Service Bulletin

Bulletin No.: 24-NA-198

Subject: Exhaust Fumes in Cabin and/or Loud Exhaust Noise

6736478

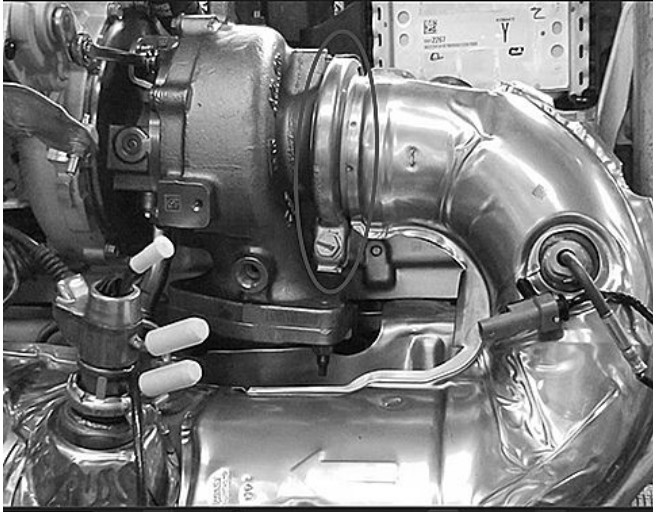
Involved Region or Country	North America
Condition	Some customers may comment on exhaust fume gas smell inside the cabin and/or a loud exhaust noise.
Cause	This condition may be caused by A misalignment between the Nitrogen Oxides Catalytic Converter and Turbocharge.
Correction	Realign and re-torque the exhaust clamp.

Inspect the connection between the Nitrogen Oxides Catalytic Converter and Turbocharge for exhaust leaks, Align the flange if necessary and torque the clamp to 12 N.m (106 lb in).
